SHELLY'S ORCHARD ADDITION

Re: S/D 9756 - One-Step Final Plat of SHELLY'S ORCHARD ADDITION

Re: S/D 97-56 - One-Step Final Plat of SHELLY'S ORCHARD ADDITION

CASE NUMBER: S/D 97-56 - SHELLY'S ORCHARD ADDITION

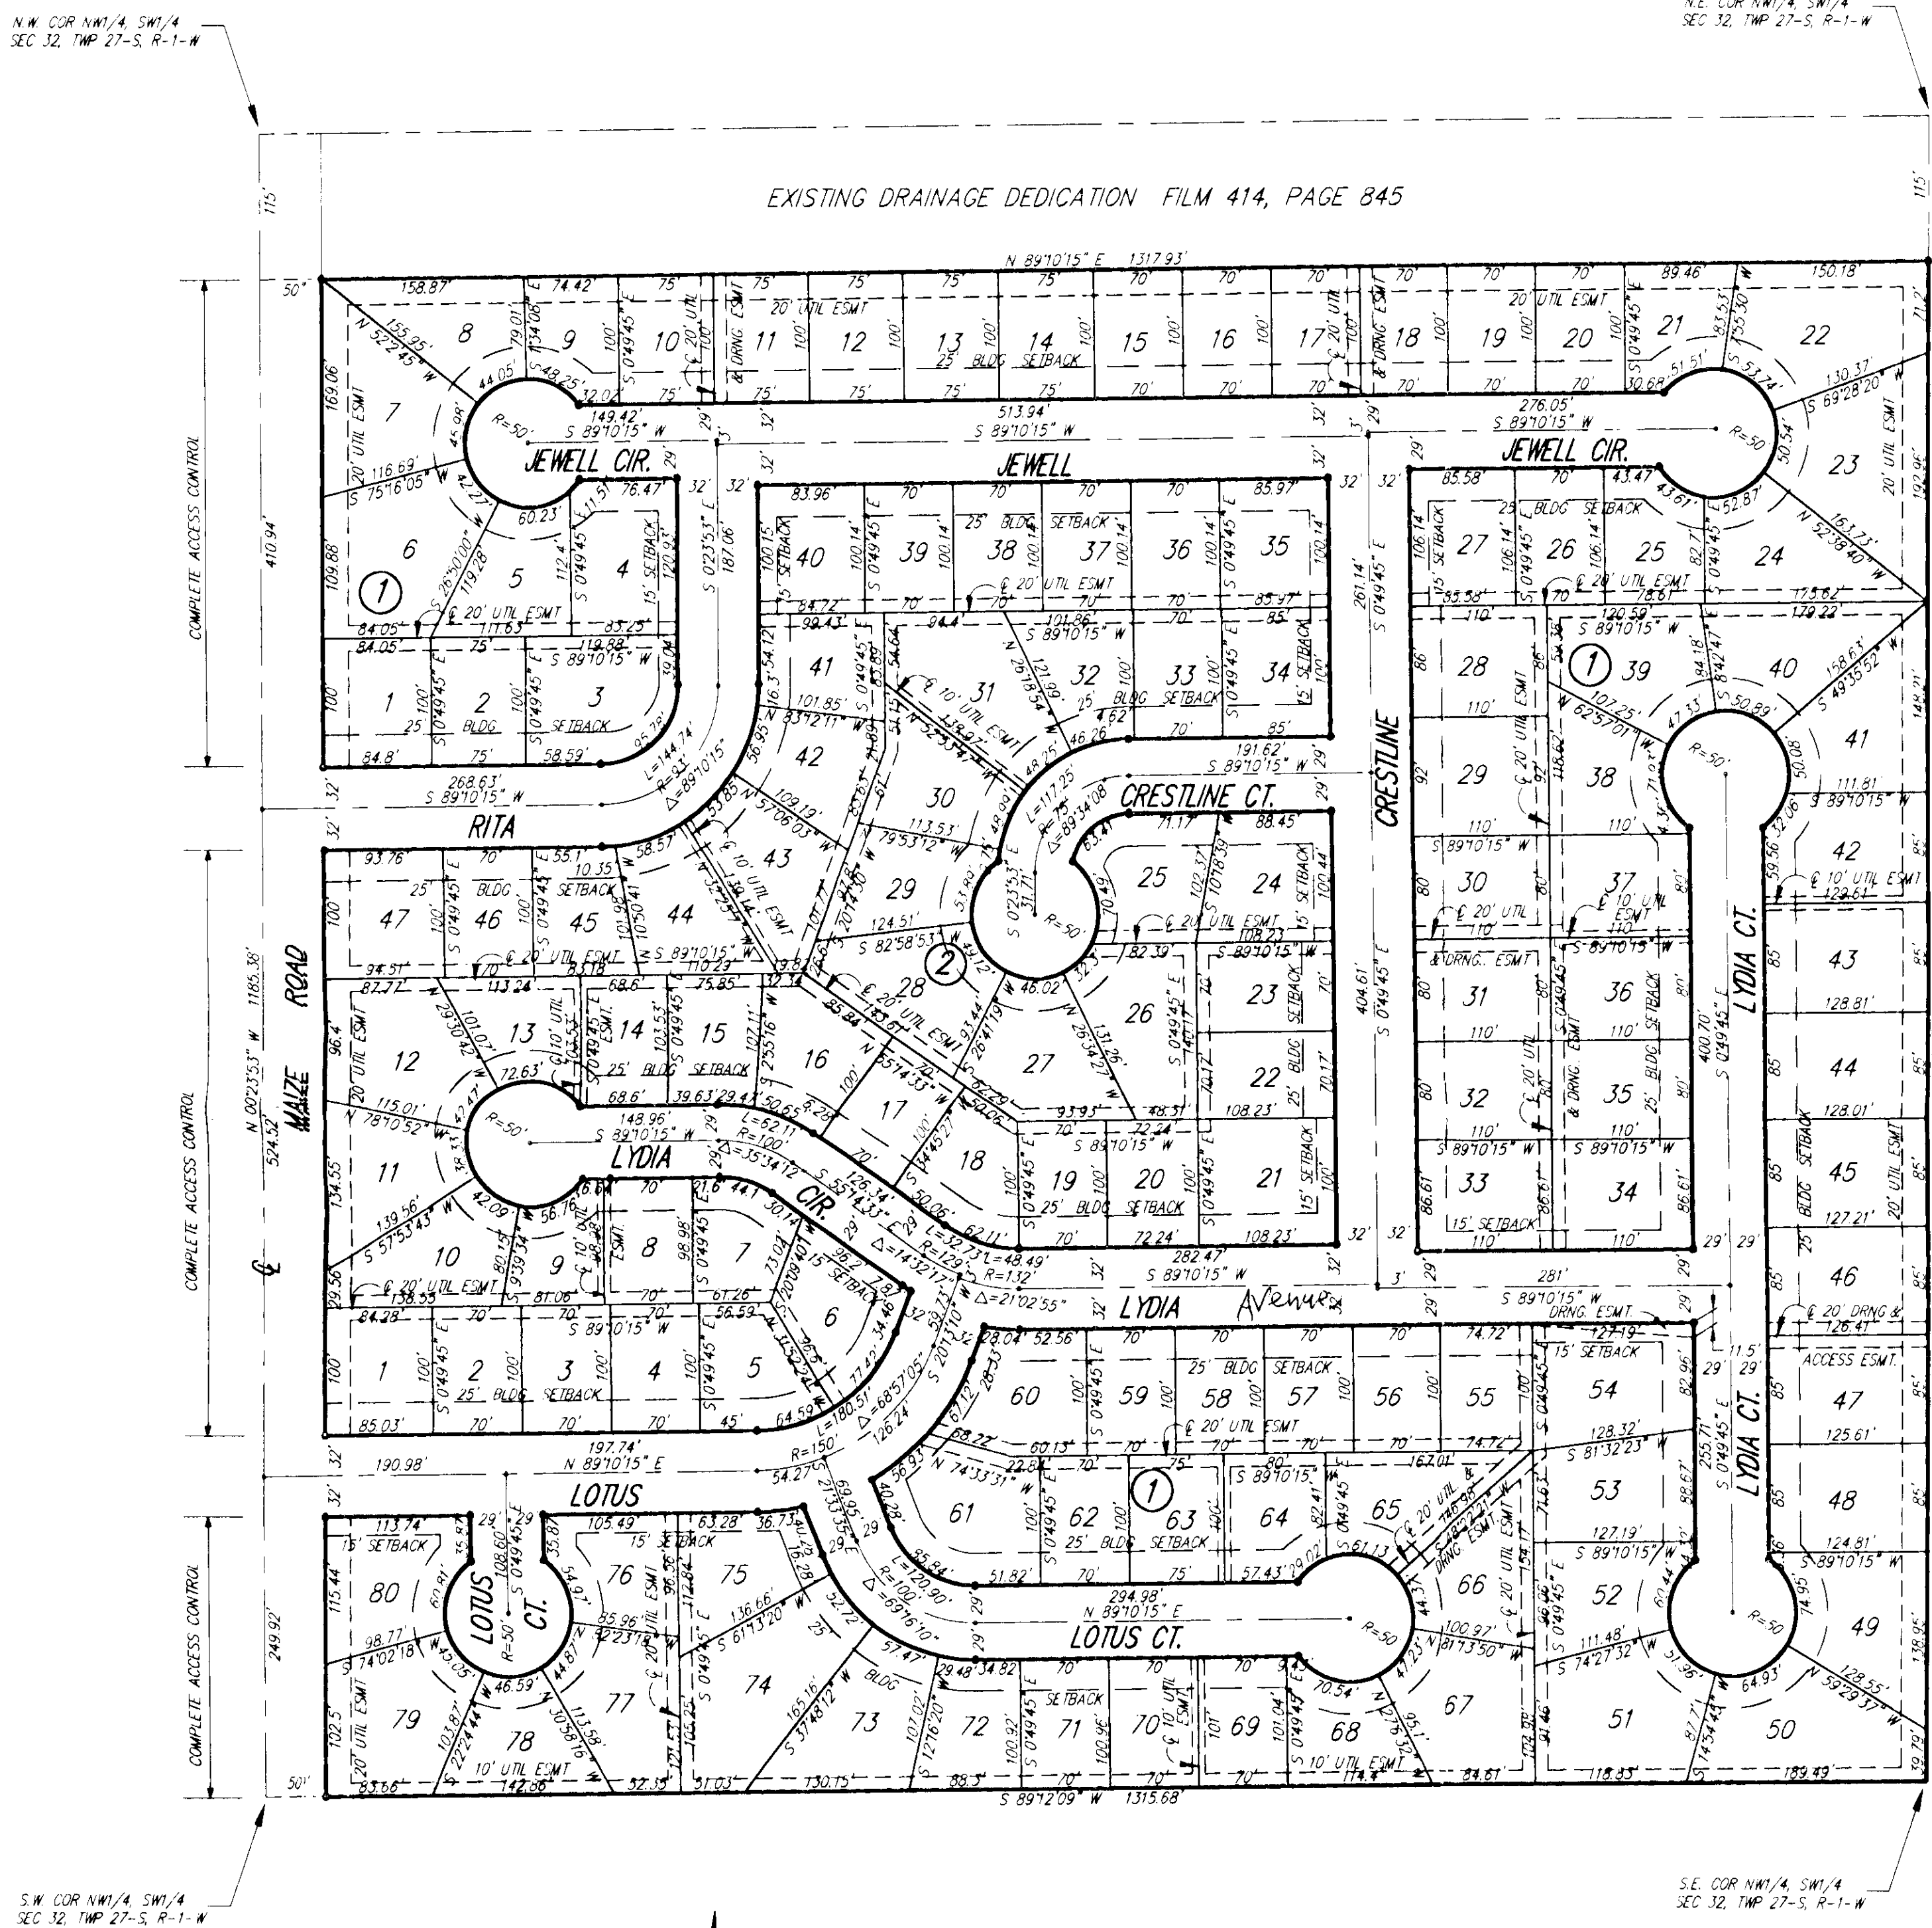
- A. The applicant shall guarantee the extension of sanitary sewer to serve the lots being platted.
- B. ✓ The applicant shall guarantee the extension of City water to serve the lots being platted.

- C. The applicant shall guarantee the paving of the proposed interior streets.
✓ Complete access should be granted for the residential lots along Maize.

- D. ✓ Sidewalks should be provided on one side along Rita, Jewell, Crestline, Lydia and Lotus.
- E. The applicant shall guarantee the construction of any drainage improvements required by the platting of this property, including storm sewers. Minimum pad elevations should be established on the lots near the drainage ditch. Drainage improvements should be guaranteed. City Engineering has approved the drainage plan.

- G. ✓ A covenant providing for 4 off-street parking spaces per dwelling unit shall be provided as required when the 58 foot local residential street standard is being used. The covenant shall inventory the affected lots by lot and block number and shall state that the covenant

- H.  Representatives from the City Fire Department comment that the street name "Fieldcrest" should be changed to "Rita". **Lydia Street should be renamed Lydia Avenue.**

- I. City Engineering indicates that the applicant's drainage concept has been approved.
- J. The applicant shall install or guarantee the installation of all utilities and facilities which are applicable and described in Article 8 of the Subdivision Regulations. (Water service and fire hydrants required by Article 8 for fire protection shall be as per the direction and approval of the Chief of the Fire Department.)

- S.  The legal description should be amended to accurately portray the location of this property. (i.e. Section 32, Twp. 27-S, R-1-W)
